Amendments/Additional Information

Your ref. NYM/2016/0416/FL

Construction of Single Story Extension at Rock House Farm, Troutdale

Res A - Slate roof - windows set back
PROPOSED ADDITIONS & ALTERATIONS TO
ROCK HOUSE FARM, TROUTSDALE,
SCARBOROUGH

FRONT ELEVATION

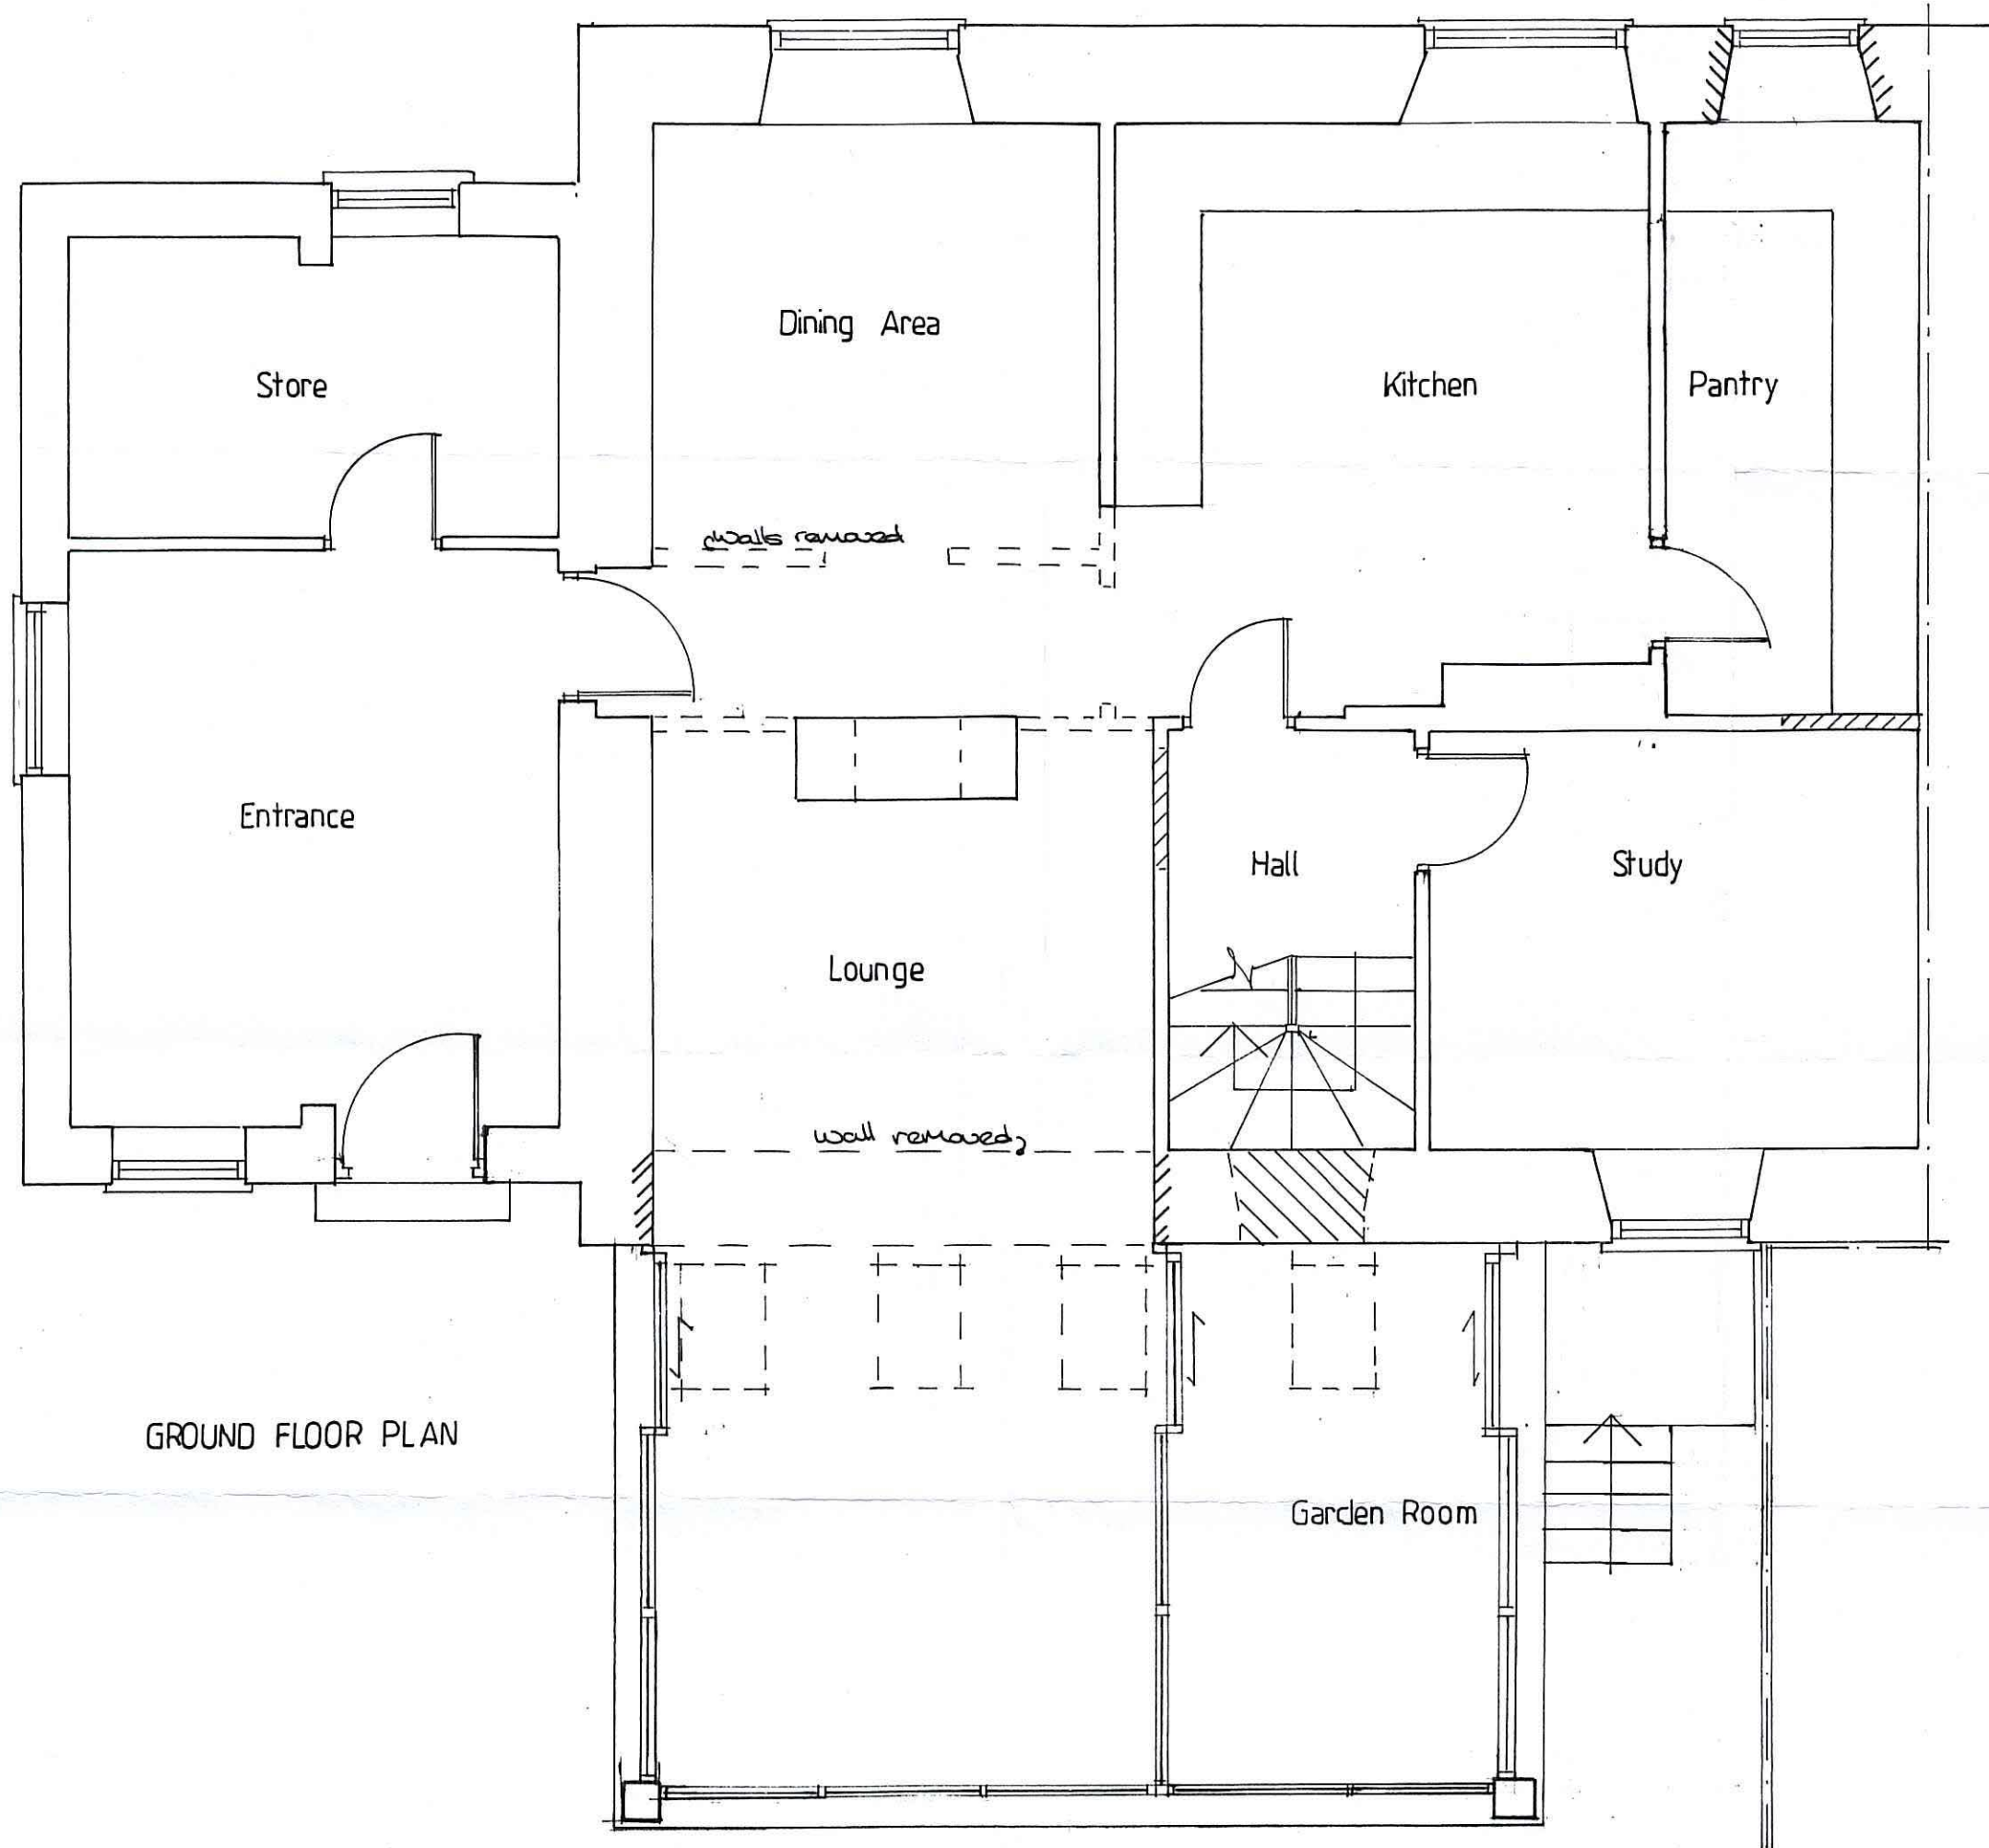
In your letter of 08/07 you recommend use of a timber frame. From our discussion on Friday, we understand that your key requirements influencing this recommendation are that the visible proportions of the main support pillars are increased and that the glass is inset. You confirmed that it would be possible to meet these requirements while retaining an aluminium or UPVC frame and we agreed to amend our proposals accordingly. Our revised plans will incorporate a deeper and wider pillar at each end of the proposed construction, a roof overhang and glass inset by between 15 and 20 cms.

In the fifth paragraph of your letter of 08/07, you express concern about the design of a proposed door opening to the right hand side (facing) of the proposed construction. We confirmed on Friday that we do not propose to have a door in this location. The opening in question is our office window and this room has been made significantly darker by the adjacent construction at Rock House Lodge. We would like to make the window longer to let in more light. We will raise the bottom of this window slightly so that it is one course of stone higher than ground level, making it more visually obvious that it is not a door.

We agreed that we would reduce the width of the extension slightly to give more balance around the ground floor window referred to above.

We confirmed that the dwarf wall around the foundations will be faced with stone to match the house.

We agreed that that there will not be a fascia panel around the new construction.

SIDE ELEVATION

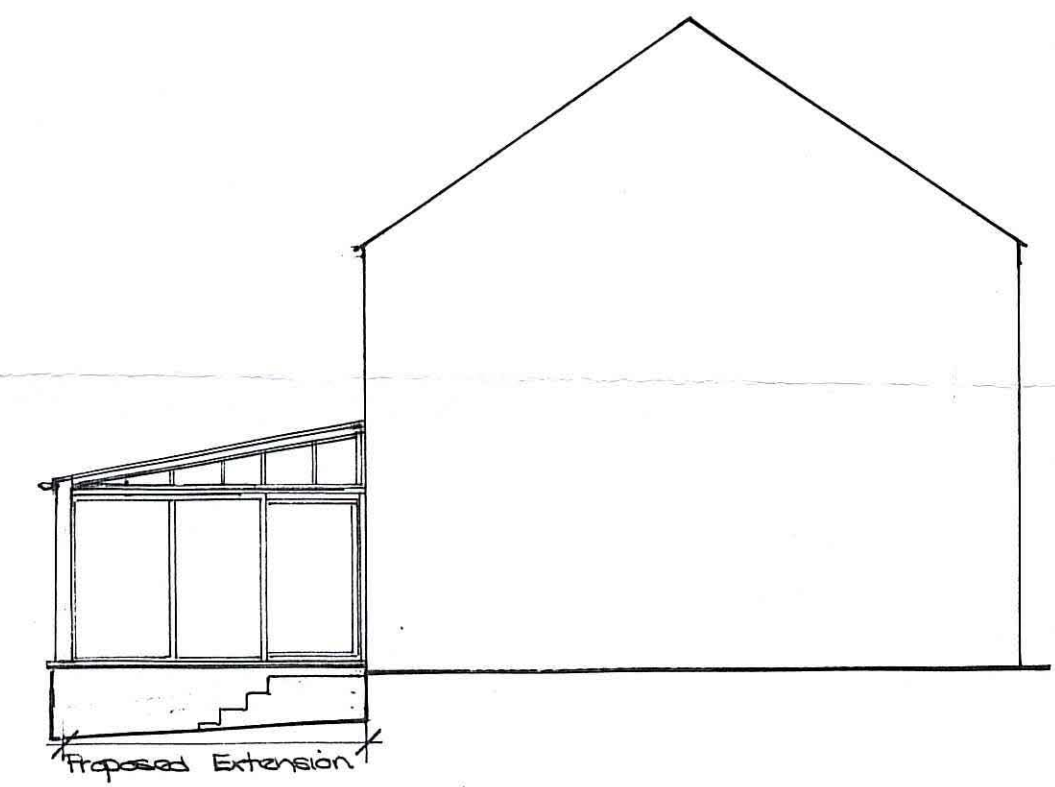
Roof material

In your letter of 08/07 you recommend the use of solid slate. We discussed the significant impact use of solid slate would have on the weight, structural design and cost of the construction and you confirmed that a visibly similar substitute would be acceptable. There is a precedent on site for the use of a slate substitute on our existing house porch roof. We agreed that Steve Parsons will provide some samples of the possible alternatives for you to review so that you can confirm your preference.
